File FPP-1996-174

Name: Entrada Townhomes II - Rana Road and Ridge Circle Drive

FILE: FPP-96-174
DATE: August 27, 1996
STAFF: Kathy Portner
REQUEST: Final Plan--Entrada Townhomes
LOCATION: NE corner Rana Road and Ridge Circle Drive
APPLICANT: The Fleisher Company

NOTE:
 APPROXIMATE DISTANCE OF PROPOSED BUS STOP
 MOVE IS 300 FEET TO THE NORTH FROM ITS
 PRESENT LOCATION.

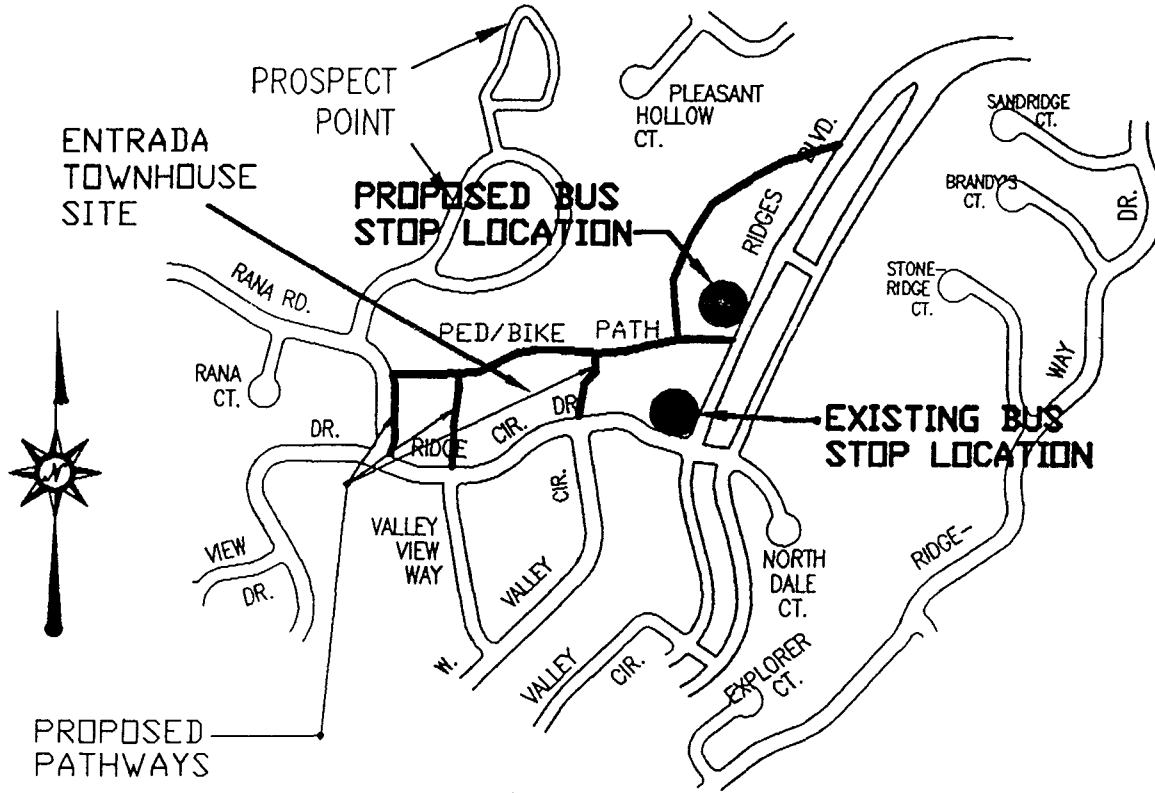
Regardless of where any bus stop is placed, motorists are required to stop behind a bus. Let's monitor the traffic flow during bus times instead of moving the stop. Most children who are serviced by the existing bus stop do not have to cross the street. Why do existing homes & families have to be inconvenienced by ENTRADA? moving the stop.
